Regarding on roll bars

FORMULA DRIFT[®]
J A P A N

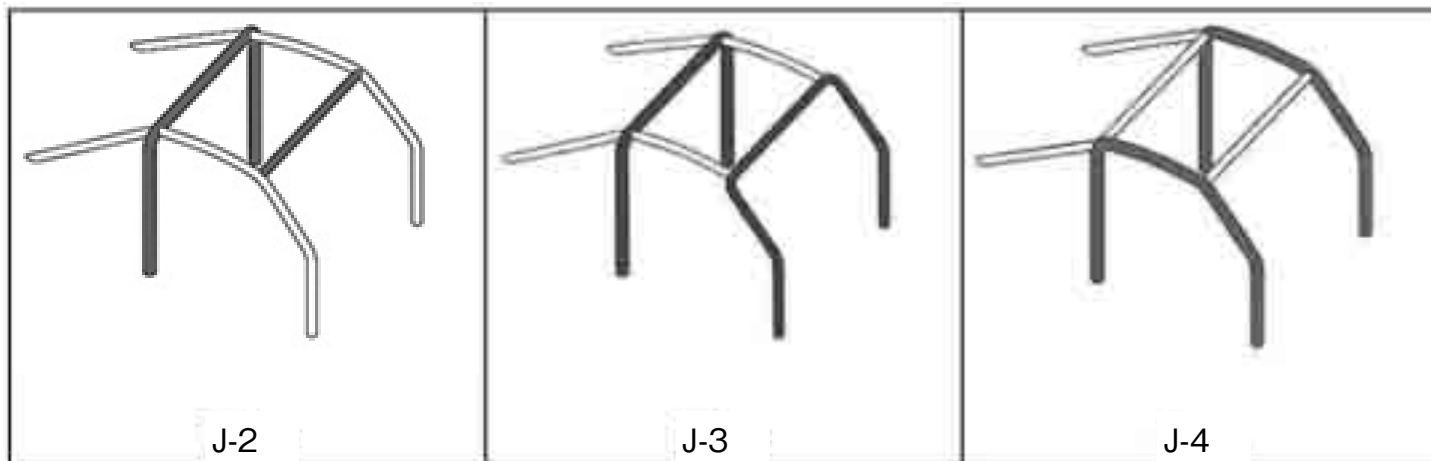
The gray part(Main Roll bar) of the illustration(J-2/J-3/J-4) must use 44.45mm x 2.5mm or 50mm x 2.0mm.

There is no structural mitigation, but with the above structure, we were able to admit the use of 40mm x 2 mm thick pipe including main hoop also in 2019.

In 2019 including the main hoop, use of 40mm 2mm thick was approved. (However, it may be 45 pie in 2020)
